Project: IEEE P802.15 Working Group for Wireless Personal Area Networks (WPANs)

Submission Title: [Suggestion for line scan LED signboard issue of Annex G]

Re: [Response to LB #57 comment]

Abstract: [This document describes the LB #57 comment resolutions related to Annex G]

Line scan LED signboard mechanism

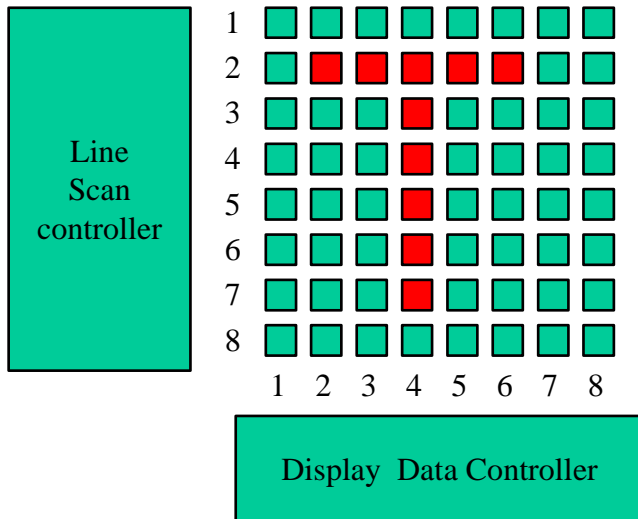
1. Let's suppose the character "T" is written on a line scan LED signboard. Let's think just one display frame time because the situations are the same in the next display frame.

2. In a display frame time, the first, the line 1 is selected by the line scan controller. This means that line 1 is on the active time. It also means that the every pixels on line 1 are ready to be "ON". But, the display data transmitted from the display data controller is nothing on line 1. So, the every pixels on line 1 display eventually "OFF".

3. And then, the line 2 is selected by the line scan controller. This means that line 2 is on the active time. This means that the every pixels on line 2 are ready to be "ON". Just the pixels shown as "red" become "red" by the display data transmitted from the display data controller.

4. In other words, the every LED pixels on a line scan LED signboard become "ON" when the line is on the active time and the display data (column) transmitted the display data controller is "ON".

5. In a line scan LED signboard, the red pixels on line 2 and a red pixel on line 3 are not "ON", simultaneously. Human eye perceive that the every red pixels showing "T" are "ON" simultaneously, but their "ON" times are different in time domain.

One suggestion – We change the every word “LED signboard” described in 10/776/r1 (Annex G) to “line scan LED signboard”.
